TITLE SO. CAL. PRESSURIZER - BRITTLE FRACTURE EVALUATION

RESPONSE TO NRC QUESTIONS

Responses to NRC Questions
San Onofre 2&3

Figure 032.39-1

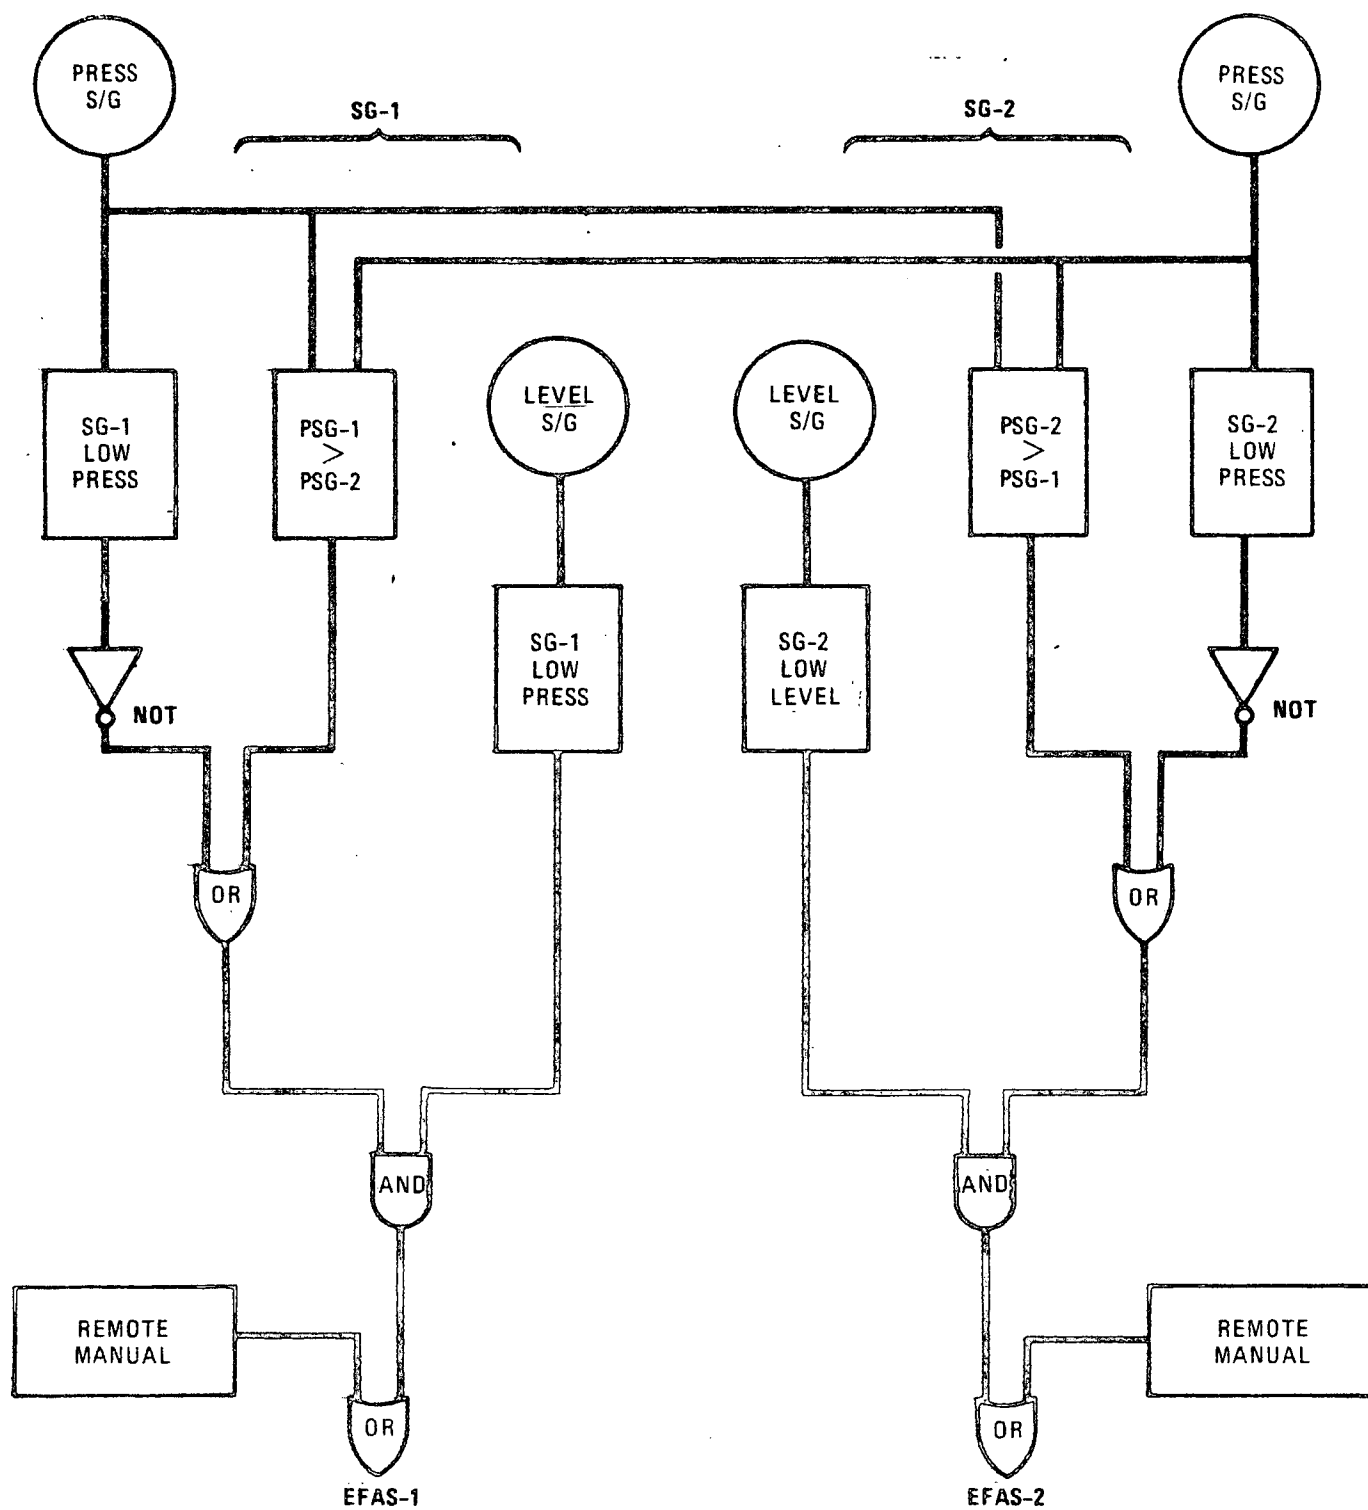
Section 7.3.1 of the FSAR states that the discharge valves of the emergency feedwater system are automatically closed to secure excess feedwater flow when the steam generator water level returns above the low level set point. Provide a detailed description of the operation of these valves, including logic and electrical schematic diagrams. Identify all valves involved in this operation.

The San Onofre Units 2 and 3 emergency feedwater actuation signal (EFAS) automatically actuates the auxiliary feedwater system by fully opening the isolation and control valves to deliver a minimum feedwater flowrate of 700 gal/min to the intact steam generator(s). The EFAS is initiated for the intact steam generator either by a low steam generator level coincident with no low pressure trip present on the intact unit or by a low steam generator level coincident with a differential pressure between the two steam generators with the higher pressure in the intact unit.

The two-out-of-four logic is provided independently for each steam generator. When steam generator water level returns to the reset point above the low level setpoint, the auxiliary feedwater system discharge valves will shut automatically as the EFAS is removed to secure excess feedwater flow. The EFAS will continue to function as required to maintain steam generator water level while the plant remains at hot standby or is brought to cold shutdown. Figure 032.39-1 shows the San Onofre Units 2 and 3 EFAS logic and FSAR figure 10.4-9 is the San Onofre Units 2 and 3 auxiliary feedwater system showing the system relationship of the valves, two motor-driven pumps and the turbine driven pump.

The third pump (motor-driven) has recently been added to the system to improve reliability resulting in a redesign of the piping system (FSAR subsection 10.4.9). The EFAS logic was not changed by this action. Subsection 7.3.1 changes to reflect the three pump system will be provided by January, 1980.
